UNITED STATES  
NUCLEAR REGULATORY COMMISSION  
WASHINGTON, D.C. 20555-0001

SUBJECT: CLASSIFICATION OF HANFORD LOW-ACTIVITY TANK WASTE FRACTION

**REPORT ON  
DOE HANFORD TANK WASTE CLASSIFICATION**

Figure 2-1. Estimate Hanford Site Tank Waste Radionuclide Inventory<sup>a,d</sup>

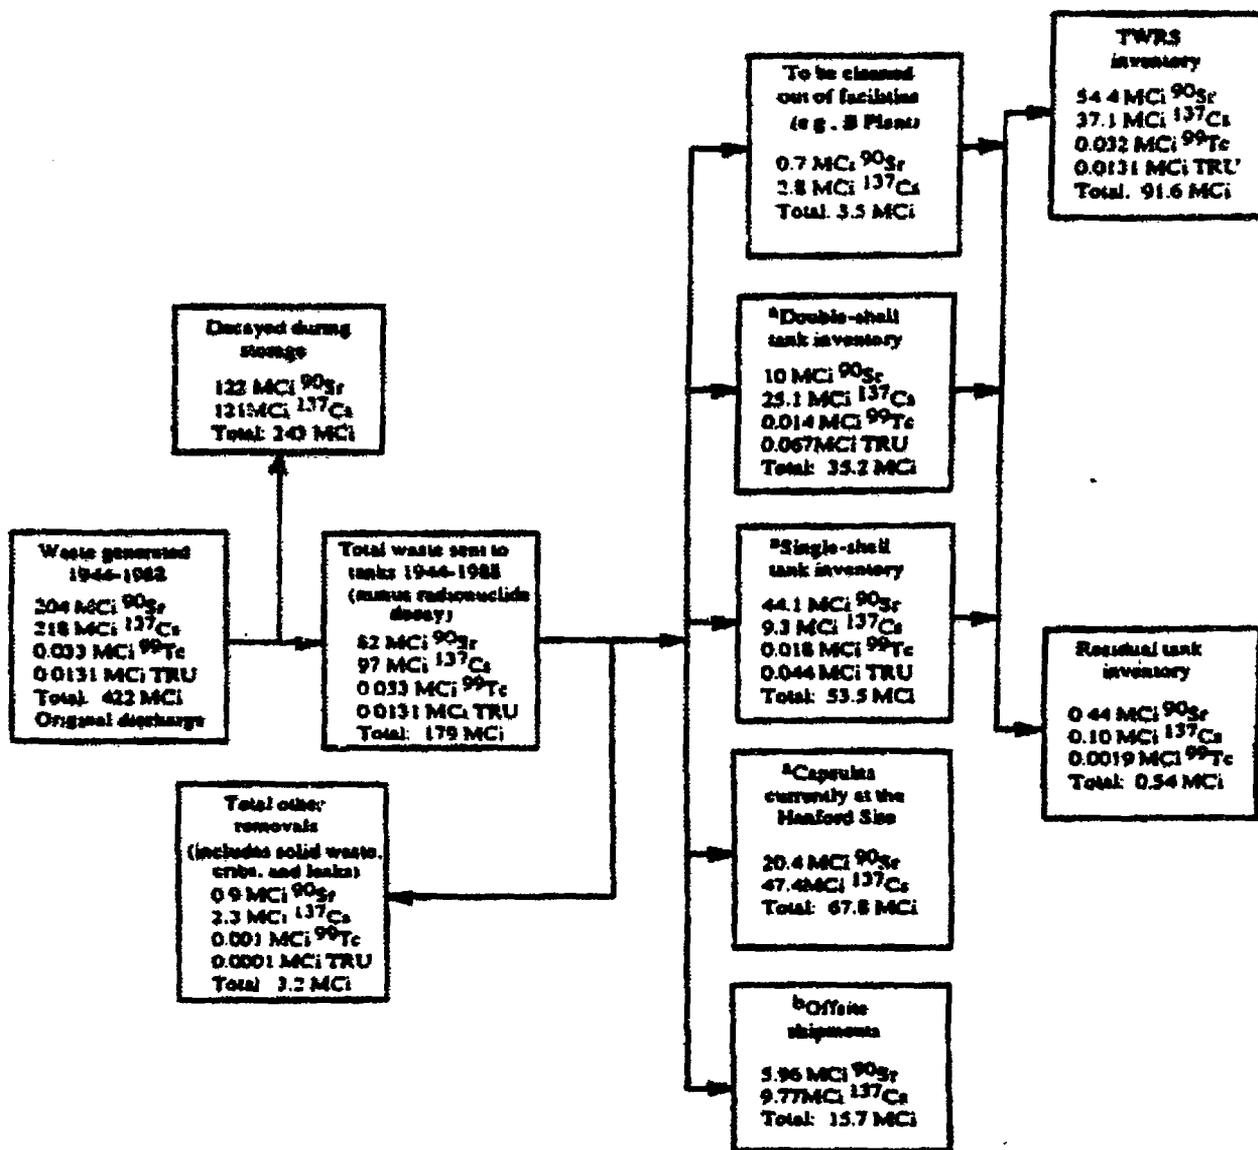
Figure 2-1, reproduced from the TBR (Westinghouse Hanford Company, 1996a, p. 3-2, figure 3-1), provides the estimated material balance for the Hanford Site tank waste radionuclide inventory. Figure 2-1 indicates that 243 MCi of the original tank waste radionuclide content of 422 MCi will have decayed by the year 1999. This value reflects the relatively short half lives of  $^{137}\text{Cs}$  and  $^{90}\text{Sr}$ . The material balance also indicates that approximately 87 MCi are accounted for as (i) leaks or deliberate discharges, (ii) encapsulation of  $^{137}\text{Cs}$  and  $^{90}\text{Sr}$ , (iii) other offsite shipments, or (iv) residual tank inventories. The remaining 91.6 MCi consists of 55.6 MCi insoluble waste to be disposed in a geologic repository as HLW and 36 MCi that comprises the soluble radionuclides that will be further treated to produce what DOE proposes to classify as incidental waste. This 36 MCi contains most of the  $^{137}\text{Cs}$  and  $^{99}\text{Tc}$  and almost all of the  $^{75}\text{Se}$ ,  $^{129}\text{I}$ ,  $^{14}\text{C}$ , and  $^3\text{H}$  (Westinghouse Hanford Company, 1996a, p. 4-1). After further treatment, 8.5 MCi will remain as incidental waste with 27.5 MCi being added to the HLW stream.

As shown in figure 2-1 of this report, 91.6 MCi comprises the Hanford Site tank waste inventory that will be processed for disposal as HLW or LLW. Approximately 99.9 percent of this waste is <sup>137</sup>Cs or <sup>90</sup>Sr. Initially, a simple solids-liquids separation will be performed on this waste to yield a low-activity liquid fraction containing the bulk of the nonradioactive materials, including about 3 percent solids carryover, and a high-activity fraction containing most of the solids. This solids-liquids separation process is expected to be relatively simple to complete and will remove approximately 55.6 MCi, consisting primarily of <sup>90</sup>Sr and TRU radionuclides (Westinghouse Hanford Company, 1996a, pp 3-2, 4-1, 4-2). Chapter 5 of the TBR concludes that, with the additional selective removal of transuranic wastes from three complexant concentrate tanks, and single-cycle ion exchange removal of <sup>137</sup>Cs from certain wastes,
